RE: Bid Title: Killlearn Lakes Drainage Project, Phase 1b  
Bid No: BC-03-14-13-27  
Opening Date: Thursday, March 14, 2013 at 2:00 PM

### ADDENDUM #1

CONC. FLUME

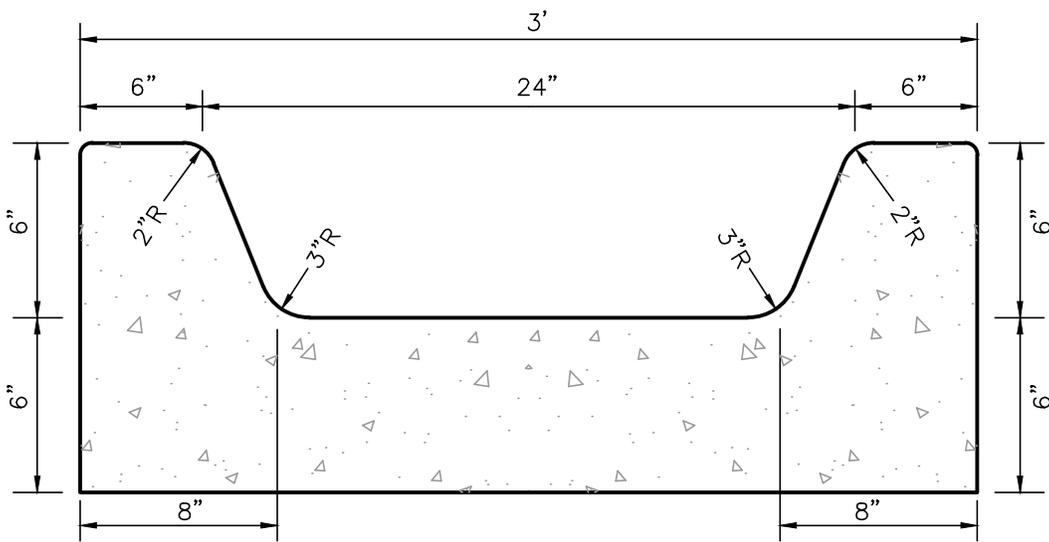
- A. No, unless LCDSEM allows
- Q. Will new concrete flumes use the same typical section as the ditch? There is no flume detail.
- A. No. For proposed flumes shown on sheets 212, 216, 220, 222, 223, & 224, the a.flume is similar to using two modified "F" curbs face to face. See attached detail. Lengths vary and are shown on the plans. For the flume shown on sheet 308, match existing flume (extend flume to new ditch bottom).

Attachment A is the detail for the Flume.
